Subject: Waterford 3 SES
Docket No. 50-382
License No. NPF-38
Technical Specification Change Request NPF-38-159

DESCRIPTION AND SAFETY ANALYSIS
OF PROPOSED CHANGE NPF-38-159

This proposed change modifies Action statement 3.6.4.2 for the hydrogen recombiners. This proposed change also modifies the Surveillance Requirements for the hydrogen recombiners to be the same as described in NUREG-1432, "Standard Technical Specifications Combustion Engineering Plants."

Figure 6.2-54

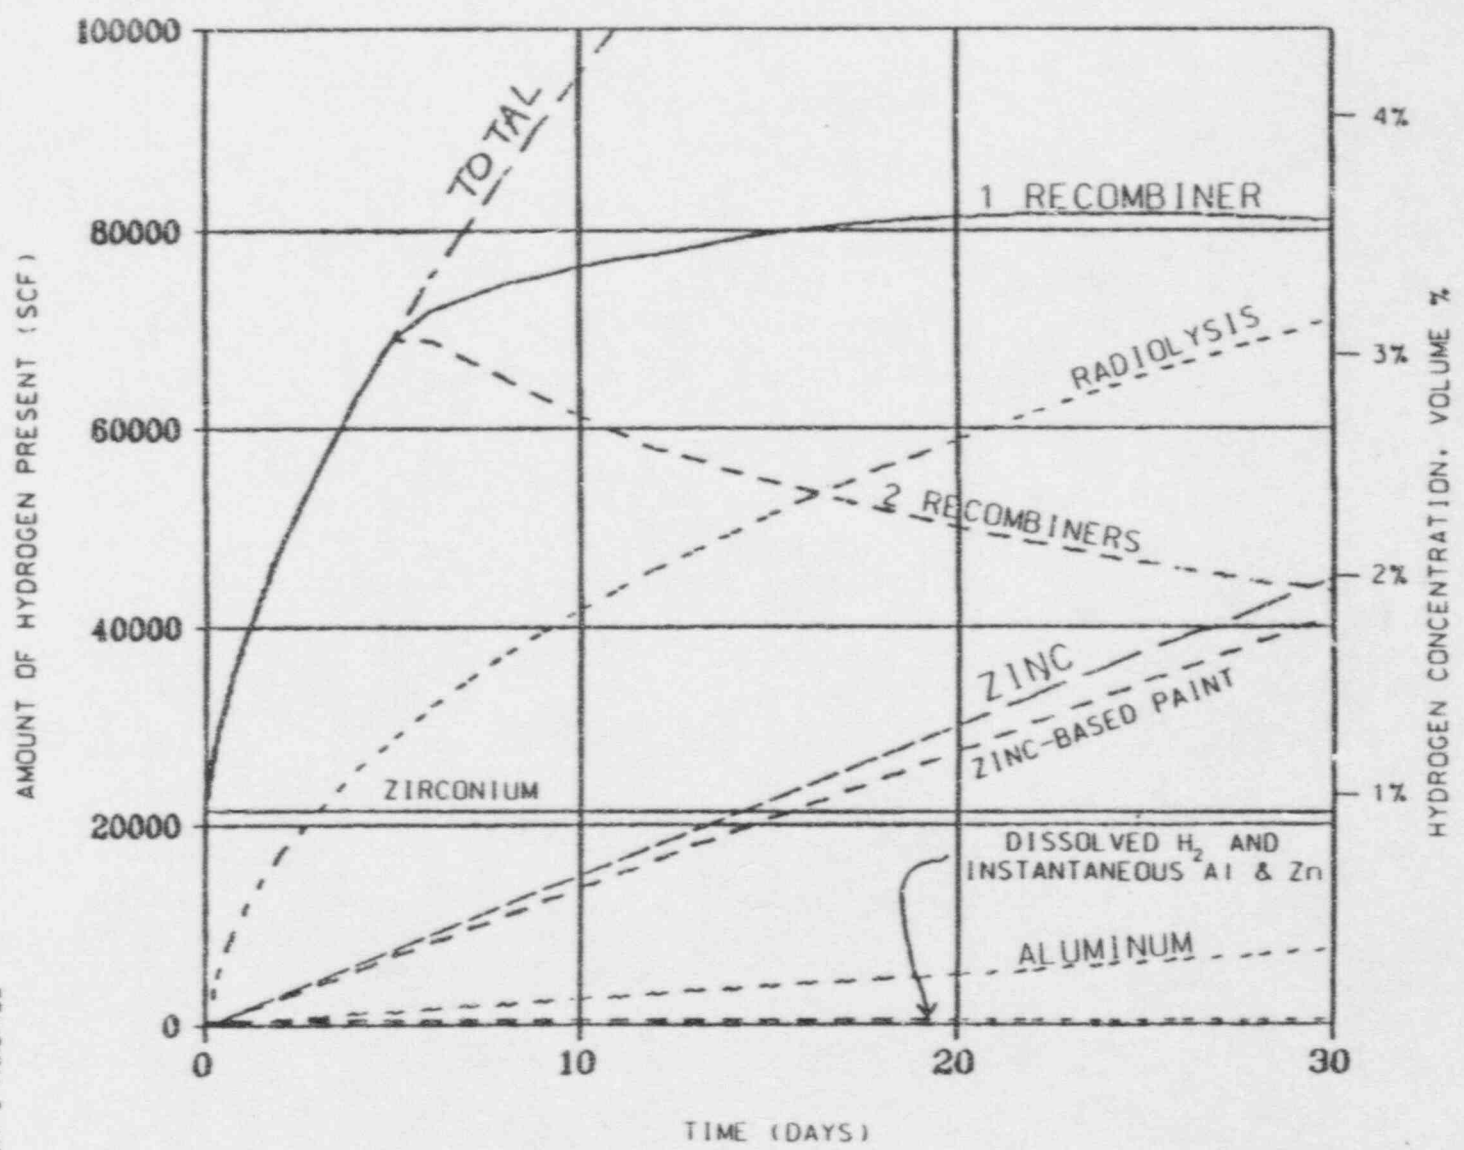
Immediately following a design basis LOCA, in the first minutes, hydrogen would be generated by oxidation of zircaloy fuel cladding. The resulting hydrogen concentration in containment would be less than 1%, reference FSAR Figure 6.2-54, attached, which is well below the 4% hydrogen flammability limit. Therefore, the hydrogen recombiners are not needed in the short-term following a design basis LOCA.

In the days following a design-basis LOCA, hydrogen will slowly build up in containment from radiolysis of water and corrosion of metallic aluminum and zinc and zinc-based paints. Figure 6.2.54 of the FSAR shows hydrogen concentrations in containment post-LOCA. Waterford 3 uses a non-zinc protective coating to prevent corrosion of zinc-based paint, so the hydrogen produced from oxidation of zinc-based paint would be significantly less than shown in FSAR Figure 6.2.54. Also, the hydrogen produced from oxidation of zirconium was increased by a factor of 5 for conservatism over the hydrogen production calculated in the ECCS performance analysis. The hydrogen concentrations are shown in FSAR Figure 6.2.54. Figure 1, see attachment A, shows these hydrogen concentrations. In Figure 1, zinc-based paint corrosion was neglected, and the FSAR Figure 6.2.54 zirconium concentration was divided by 5. The other hydrogen concentrations were taken directly from FSAR Figure 6.2-54. The total hydrogen shown in Figure 1 was calculated by adding

the curves for the hydrogen sources shown in the figure. Using these total hydrogen values, the hydrogen concentration, without recombiners, will reach the 4% concentration flammability limit at 17 days and be about 5.7% at 30 days which is less than the 6% flame propagation limit. Regulatory Guide 1.7 establishes that for hydrogen concentrations between 4% and 6%, only partial burning will occur, which will not result in effects that would be adverse to containment systems. A time period of 30 days would provide ample time within which to mobilize resources to repair the hydrogen recombiner system(s) or to implement long term recovery actions, such as containment venting, for example, by using the Containment Atmosphere Release System, (CARS).
